September 17, 1992

Refer to: HNG-14/SS-30

Geometric and Roadside Design Acceptance Letter Number SS-30

Hapco Test Pole No. TP3267

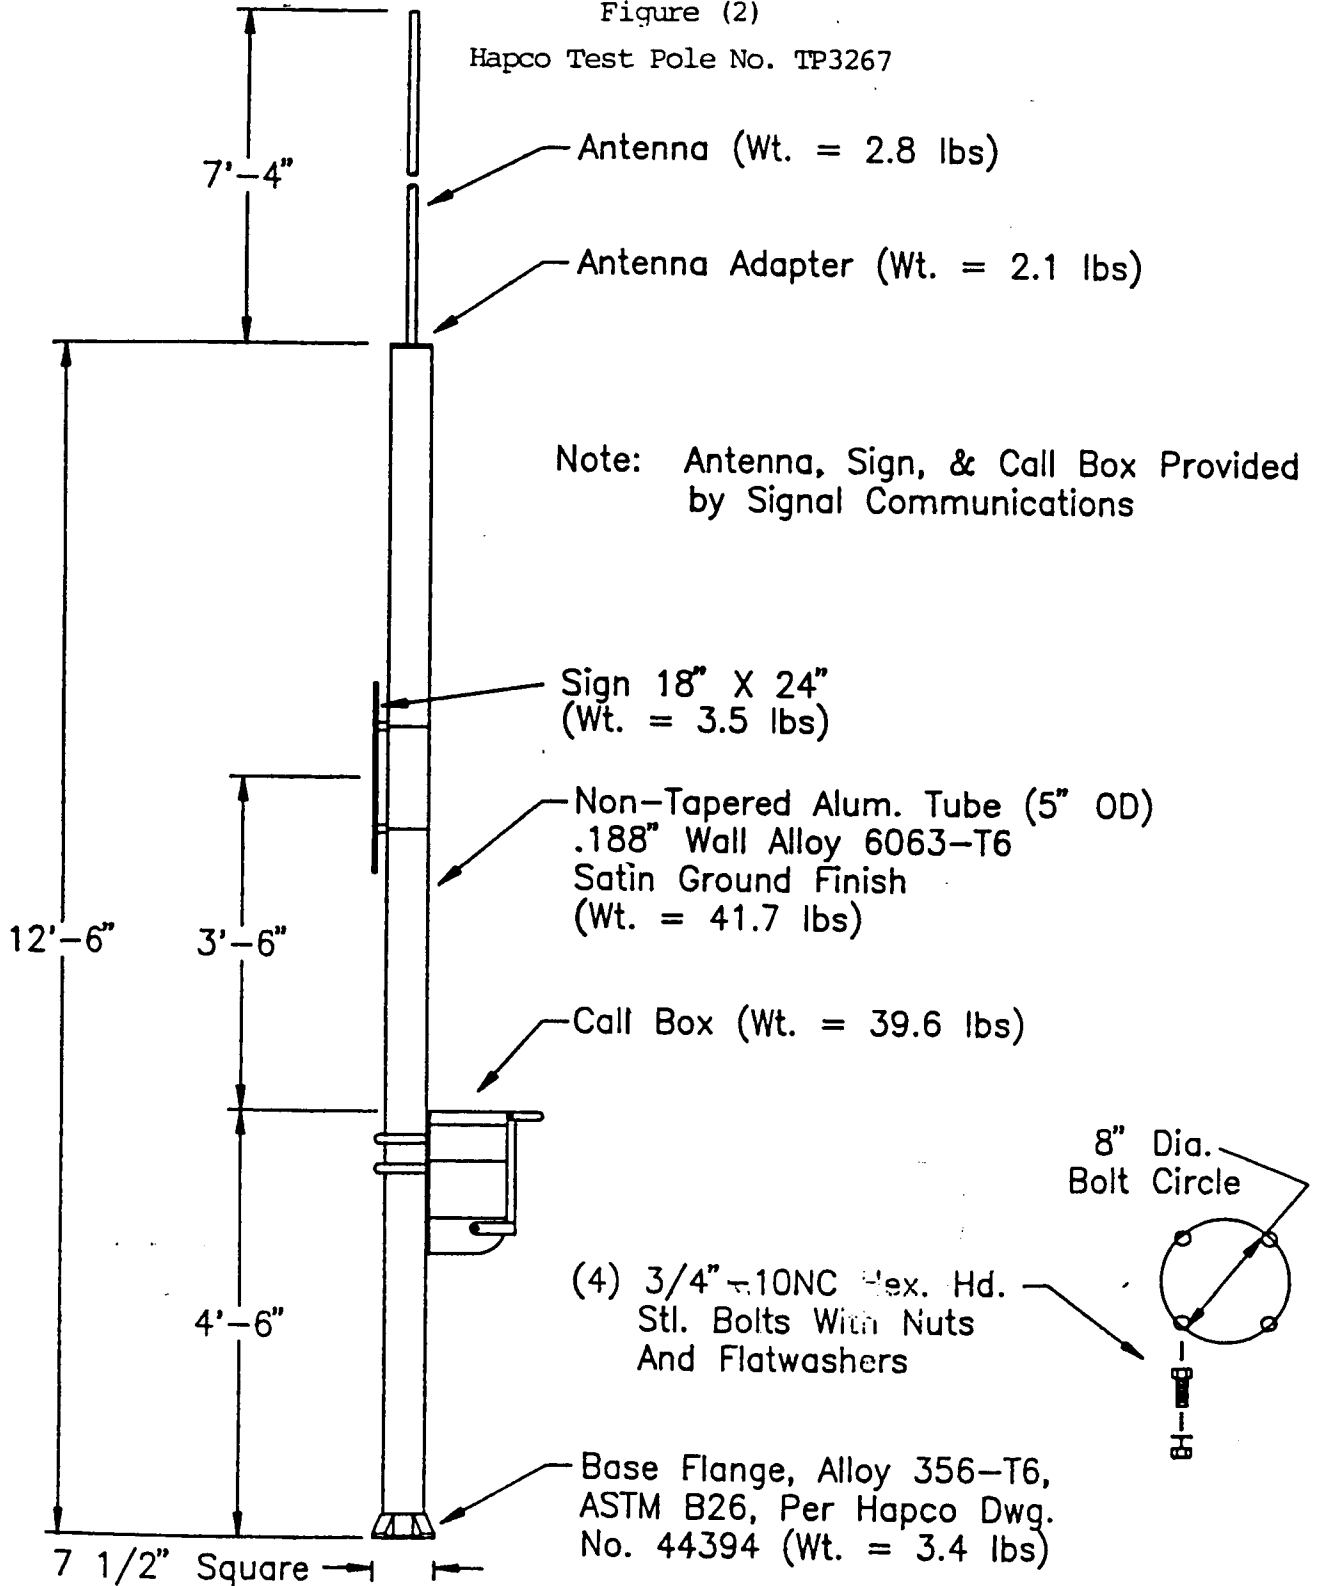
Pole Type	6063-T6 aluminum Hapco Pole, Drawing TP 3267
Pole Wall Thickness, mm (in)	4.77 (0.188)
Base Type	356-T6 Alum. Shoe Base C-44394, 7.5-inch to 8-inch Bolt Circle
Call Box Mass, kg (wt, lbs.)	17.5 (38.6)
Test Article Mass, kg (lbs.)	40.9 (90.0)
Overall Height, excluding antenna, m (ft.)	3.8 (12.5)
Pendulum Mass, kg, (lbs.)	818 (1800)
Impact Speed, km/hr, (mph)	31.6 (19.6) 28.8 fps
Velocity Change, m/s (fps)	2.40 (8.0)
Calculated High Speed Velocity Change, m/s, (fps)	1.5 (4.9)
Stub Height, mm, (in)	50 (2)

The results of this test meet the change in velocity and stub height requirements adopted by AASHTO and the FHWA. Therefore, your company's breakaway shoe base described above is acceptable for use on Federal-aid highway projects, within the range of conditions tested, if proposed by a State.
